# Access Compliance Report

## Public Rights-of-Way

| Intersection ID: 49690                  | Main Street: ALEXANDRA_ALLEY_DR | Cross Street: SHARON_HILLS_RD           | Location: E            |
| ADA ID: FD7FDE7D1CA6                    | Ramp Type: BlendTrans1          | Initial Pass/Fail: Pass                 | Overall Compliance: No |

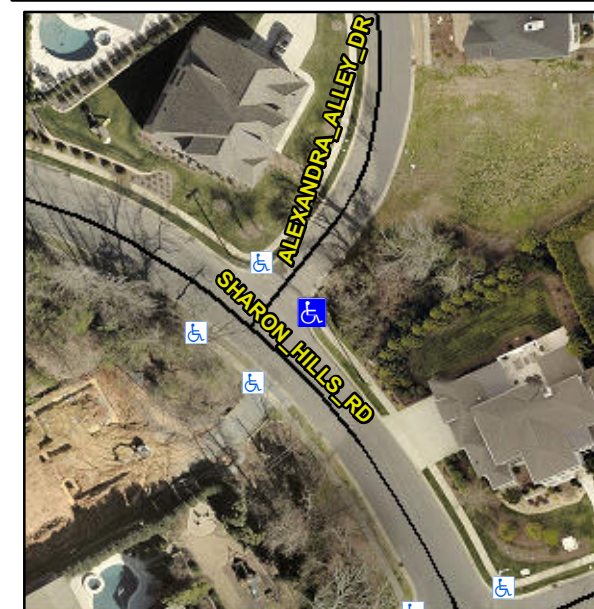
**Not Found, R304.5.3, R304.2.1, R302.7, R304.5.4**

| Compliance | Description           | Data   | Compliance | Description                 | Data   |
|------------|-----------------------|--------|------------|-----------------------------|--------|
| Yes        | Ramp Width (in)       | 48.0   | No         | BlendTrans XSlope (%)       | 2.1    |
| No         | Landing Length (in)   | 46.0   | Yes        | DWS Provided?               | Yes    |
| No         | Landing X Slope (%)   | 2.7    | Yes        | DWS Full Width?             | Yes    |
| No         | Gutter Ponding?       | Yes    | No         | Gutter Slope (%)            | 8.0    |
|            |                       |        | No         | Curb Slope (%)              | 12.4   |

**Remove & Replace Curb Ramp With Two New Directional Ramps or Equivalent. Remove & Replace Gutter.**
